FDOT INDEX #200/201 P-7 STORM MANHOLE # S-115

FDOT 434986-1-52-01

STRAIGHT AHEAD CONSTRUCTION

FORTERRA | PIPE & PRECAST

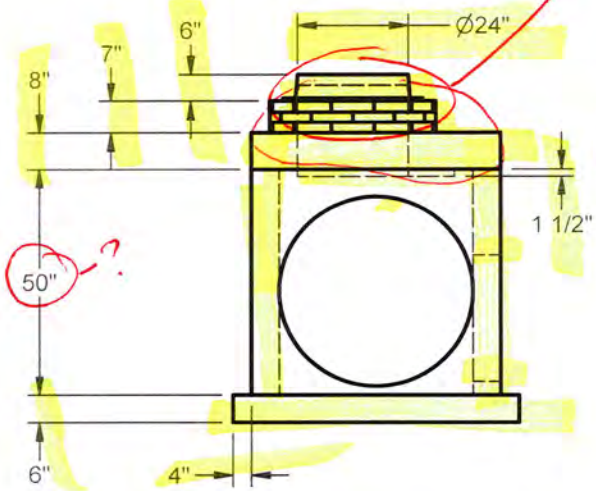
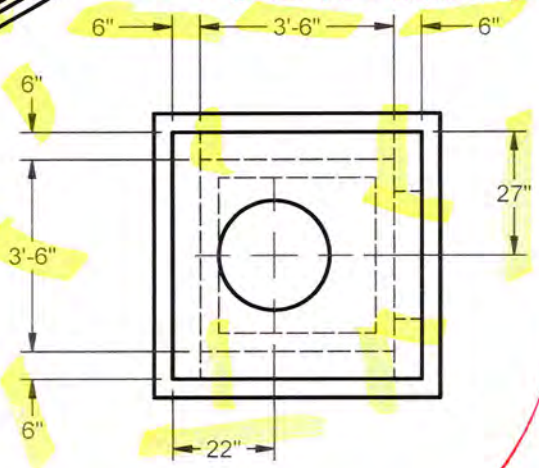
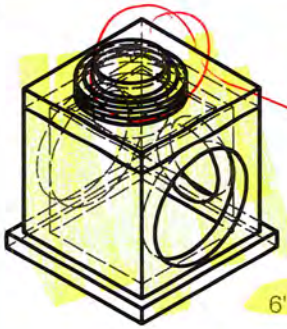
CONTRACTOR CHOOSING TO USE TYPE 7 MH. PLANS CALL FOR TYPE 8 MH (ALT. B) BOTTOM.

PROPOSED TYPE 7 IS ACCEPTABLE WITH THE 7" BRICK ADJUSTMENT PROVIDED.
